ORDINANCE NO. 1852-18

AN ORDINANCE GRANTING PRELIMINARY PLANNED UNIT DEVELOPMENT PLAN APPROVAL, GRANTING PRELIMINARY SUBDIVISION PLAT APPROVAL, GRANTING PRELIMINARY ENGINEERING PLAN APPROVAL, GRANTING PRELIMINARY LANDSCAPE PLAN APPROVAL, AND GRANTING CERTAIN RELIEF FROM THE VILLAGE'S ZONING ORDINANCE, SUBDIVISION CONTROL ORDINANCE, AND BUILDING REGULATIONS ORDINANCE— K. HOVNANIAN T & C HOMES AT ILLINOIS LLC—THE VILLAS AT THE COMMONS—NORTHWEST CORNER OF MIDLOTHIAN ROAD AND LANDOVER PARKWAY

SUBJECT: The Villas at the Commons (TEF West) – Prelim Plans – 2nd Review

EXHIBIT "C-1"
PRELIMINARY PLAN

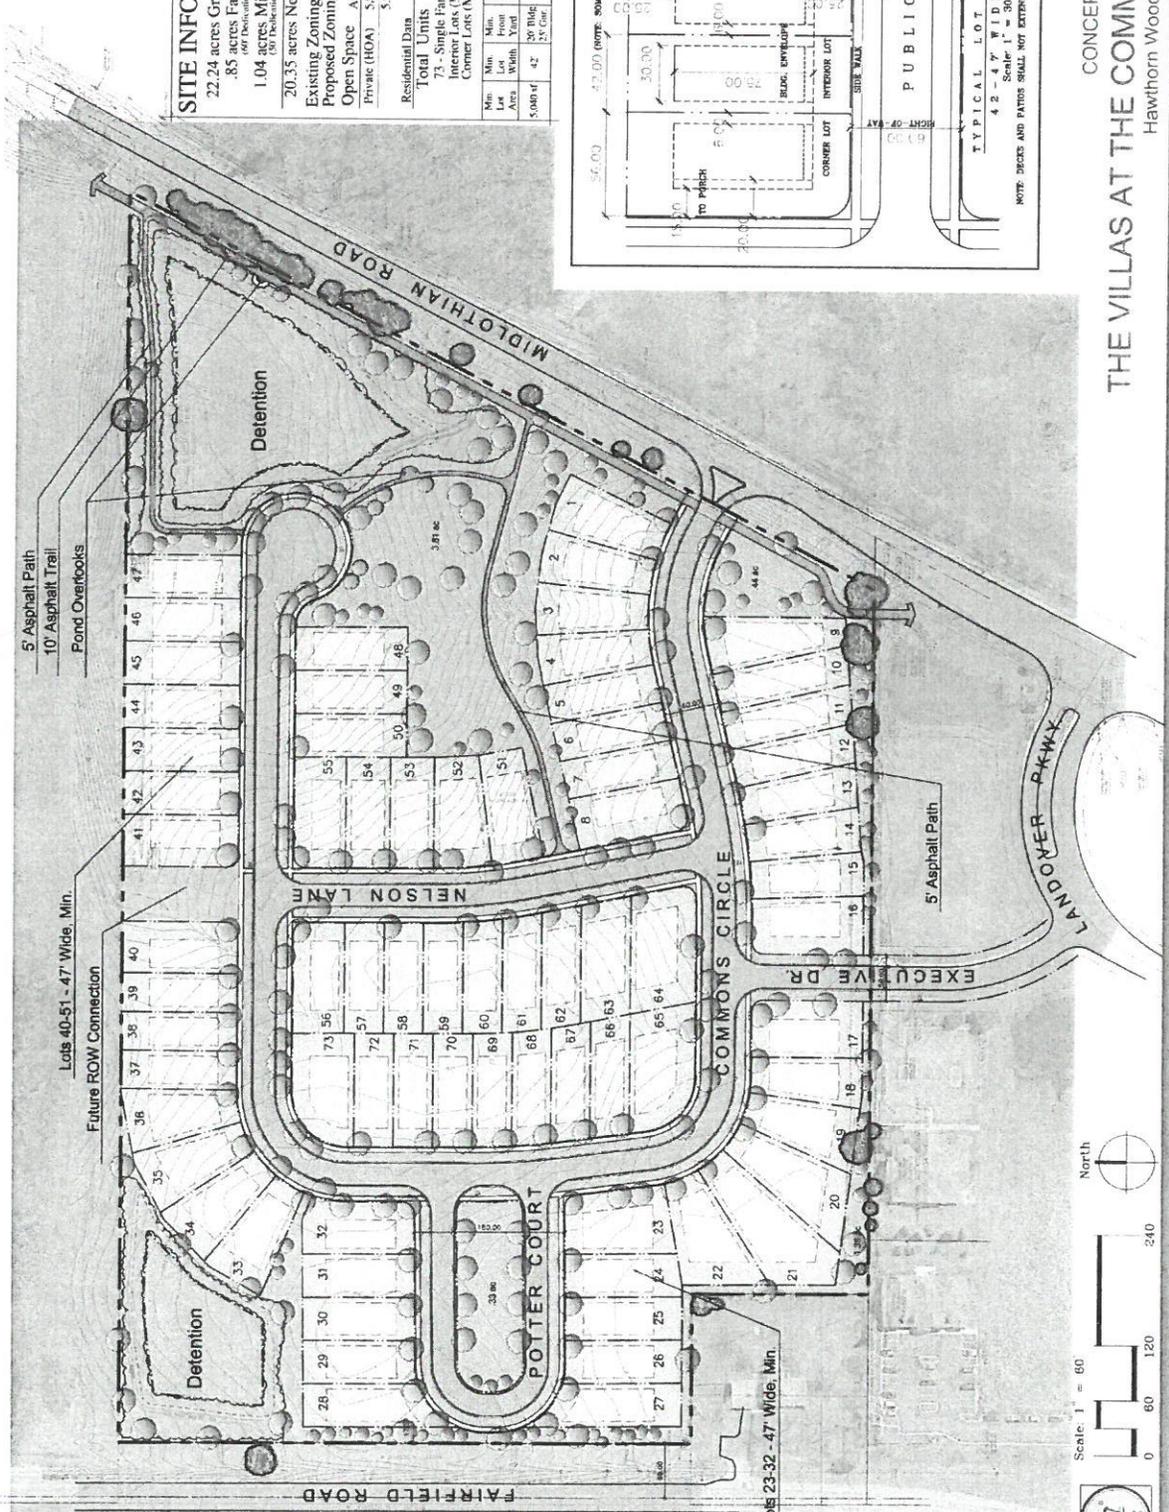
3. In addition to the Typical Lot Diagram and the Site Information block, please add a Site Data Table with the following information:

4. Add the existing and proposed zoning districts to the Site Information block.
 - a. Added COMPLETED.
5. Confirm decks and patios will not extend into the interior side yard setback. This will be a condition of approval.

- a. Decks and patios will NOT extend into the interior side yard setback HW RESPONSE: NOTED.
6. Confirm driveways will not be closer than seven feet (7') from the side yard lot line. Indicate the distance on the Typical Lot Diagram.

- a. We are not proposing to construct a subdivision sign. HW RESPONSE: NOTED.
10. Is the minimum side yard setback five feet (5') or six feet (6'). The Typical Lot Detail in the Preliminary Plat, page 2, is confusing as it doesn't match the Typical Lot Diagram on the Concept Plan.

This site data table has been added to the preliminary site plan. HW RESPONSE: Please confirm garage setback of 25' has not changed since garage depths were increased by 2 feet. The garage setback has not changed.

- a. This note has been added to the Typical lot Diagram on the preliminary site plan COMPLETED.
7. Ensure corner lot parkway trees do not create a vision clearance issue for turning vehicles. See Village Code Section 9-3-2.F.

- a. Minimum side yard will be six (6) feet. HW RESPONSE: NOTED.
11. What is the maximum impervious surface ratio for the most built out lot, including decks, patios, driveway, sidewalks, etc.?

UTILITY PLAN

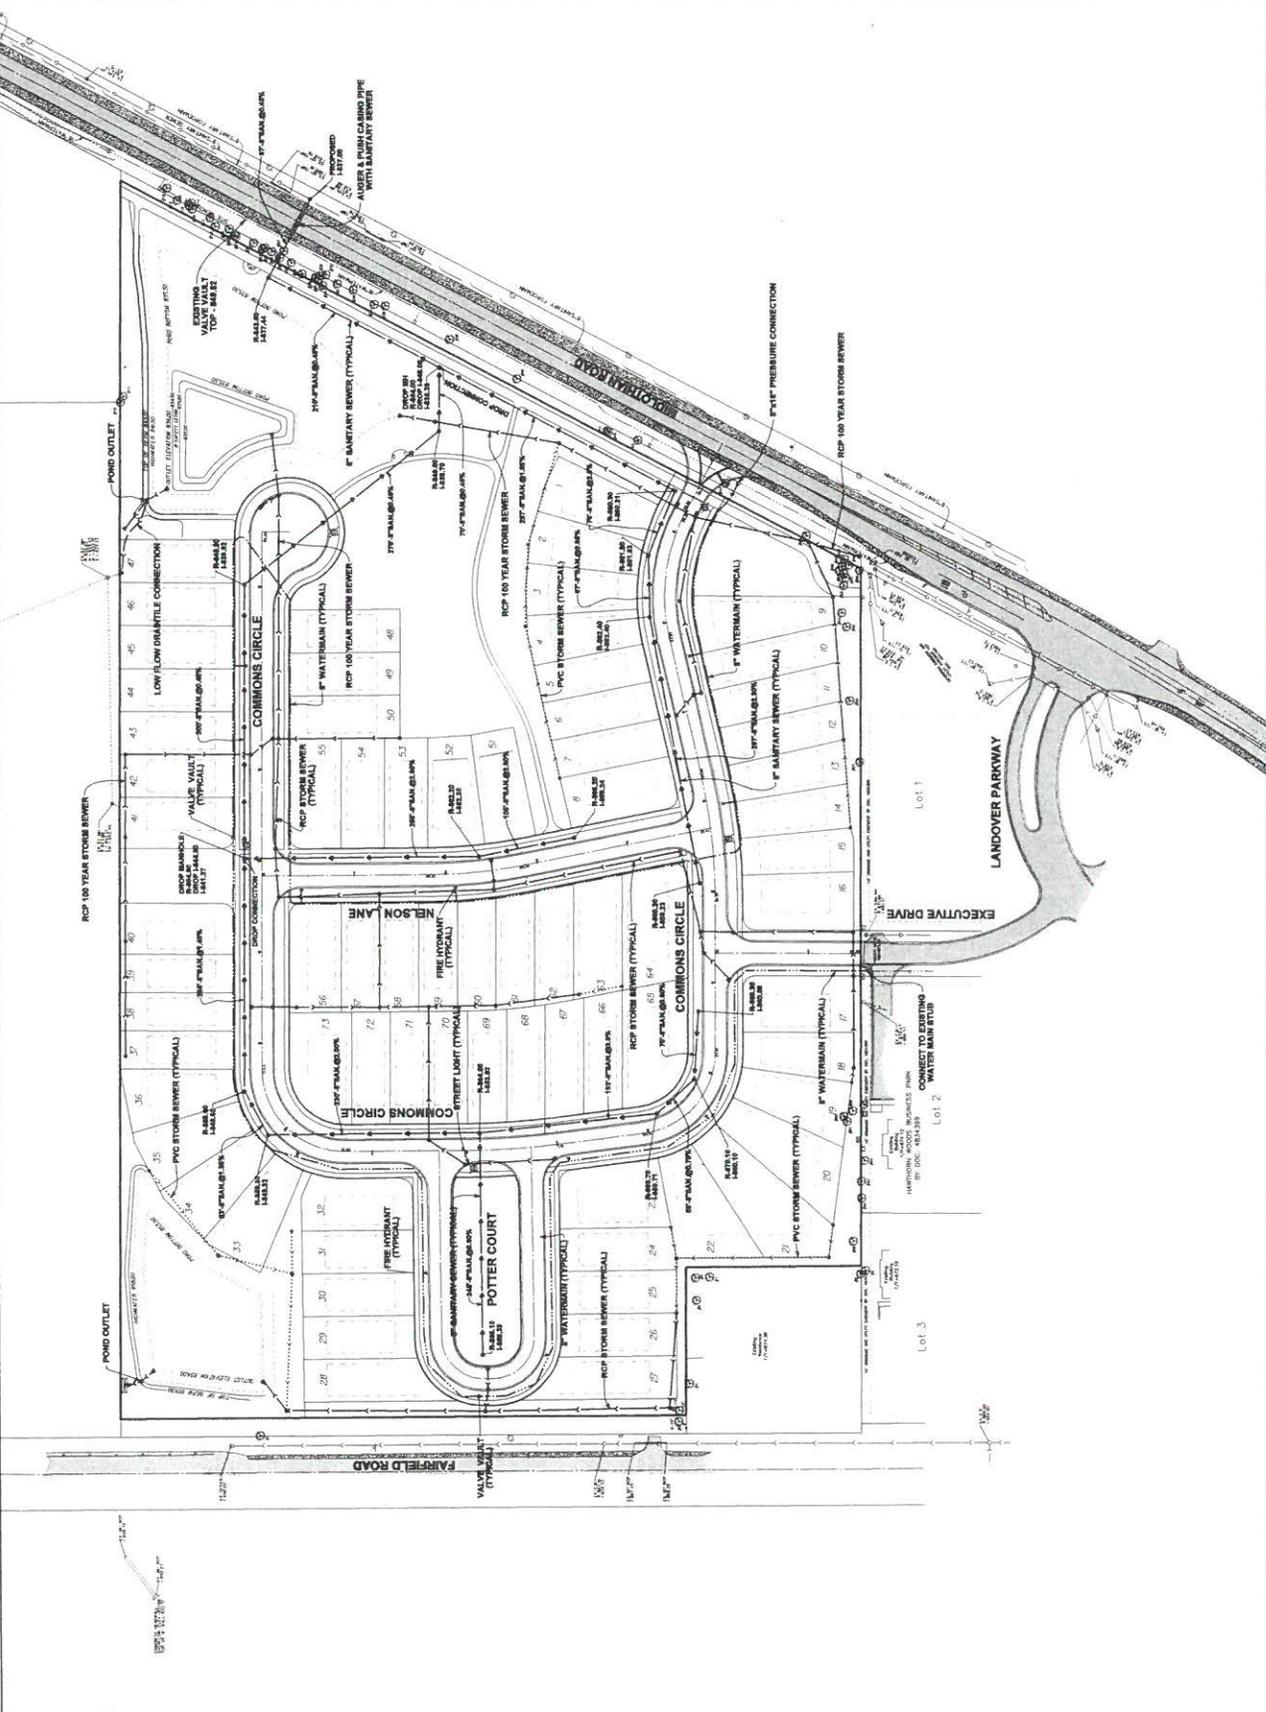
- 18. Include a street light in cul-de-sac at the southeastern edge near the trail and playground area.
 Revised as requested (See preliminary engineering Sheet 5) **HW RESPONSE:** COMPLETED

TYPICAL FOUNDATION PLAN

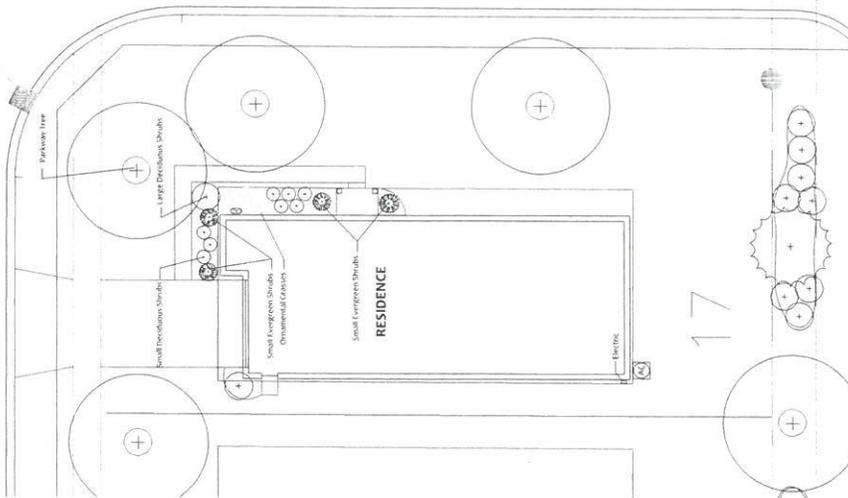
24. Provide a typical lot plan with the largest house footprint showing the mechanical equipment (air conditioning unit) and landscaping.

A detail has been provided for the ranch model which has the largest footprint. (Sheet L3) HW RESPONSE: COMPLETED

ARBOR ELEVATION

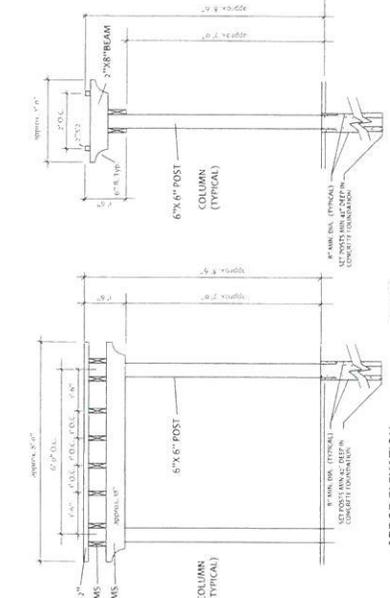
22. Provide a color callout for the arbor(s).

The arbor shall be white Trex or similar material. This will be specified at time of Final Landscape Plans. (Sheet L3) HW RESPONSE: NOTED
